REQUEST

Approximately 45.67 acres located on the west side of South Tryon Street, north side of Clanton Road, and east side of Interstate 77.

SUMMARY OF PETITION

PLANNING STAFF REVIEW

• Proposed Request Details

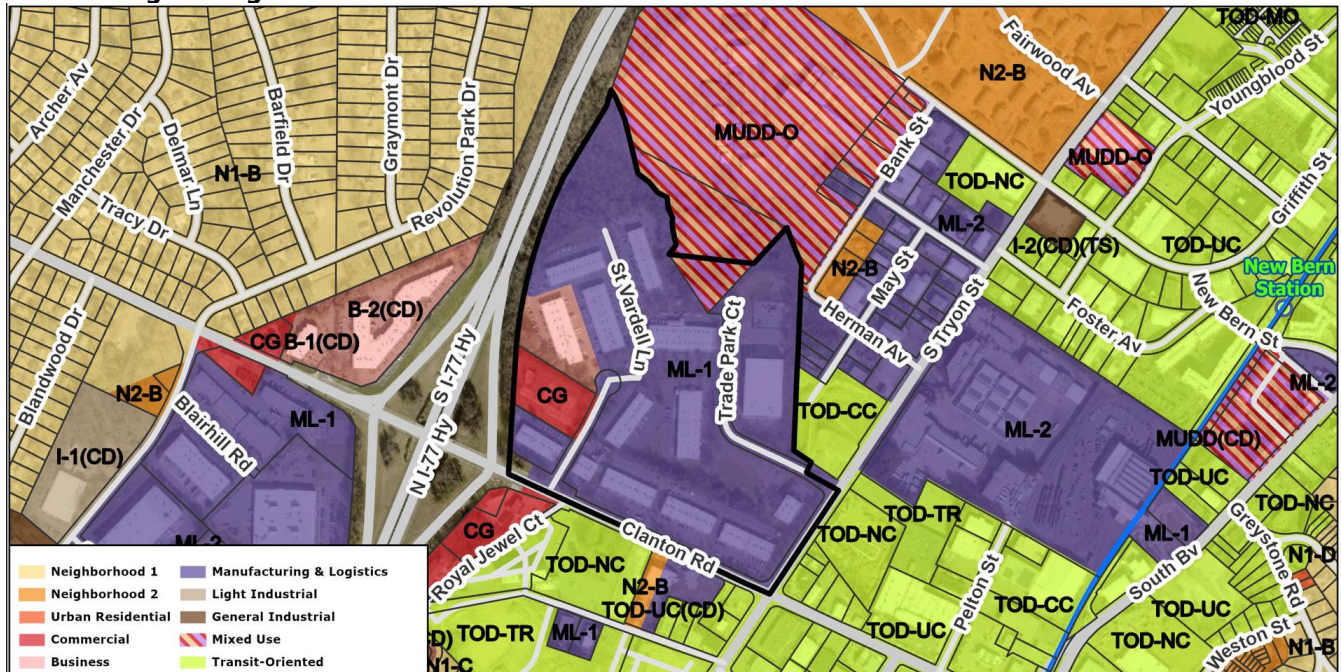
- Allows all uses permitted by-right and under prescribed conditions in the MUDD zoning district together with accessory uses. Prohibits automotive service/gas stations with accessory car washes, commercial self-storage facilities, and drive-in windows outside of ~~Development Areas A and D~~ Development Area A2. There shall be no more than one gas station and two accessory drive-through windows in Development Area A2.

- Allow a maximum building height of 180 feet.
 - Allow drive-in windows as an accessory to the principal uses located in **Development Area A2** ~~Development Areas A and D~~. For a restaurant/bar principal use to have an accessory drive-through, it must have a minimum of 24 seats.

4. ~~Provide detail on which development area(s) the gas station may be located in and provide a limitation on the number of pumps that would be in the gas station use. Consider adding a commitment to EV charging stations.~~ **Addressed**

5. ~~Revise the design standards for gas stations to commit to a minimum ground floor height for gas stations and orientation of canopies to the rear or side of the street.~~ **Addressed**

7. ~~Revise the design standard notes for drive-throughs so that no drive aisle may be located between the building façade and the street, menu boards may not be visible from the street, and note that seat walls that meet screening requirements will be provided to enhance the pedestrian environment.~~

8. ~~Commit to a maximum number of principal uses may have an accessory drive-through and provide further limitations on which part of the site may have an accessory drive-through, allowing this use on approximately 1/3 of the site is too broad. Staff would support modifying the note to only allow accessory drive-throughs in Development Area A2.~~ **Addressed**

Addressed

2. ~~Include a commitment to construct an ADA compliant bus stop along Clanton Road.~~ **Addressed**

3. ~~Increase the specified minimum transparency for upper floors from 15% to 25%.~~ **Addressed**

Addressed
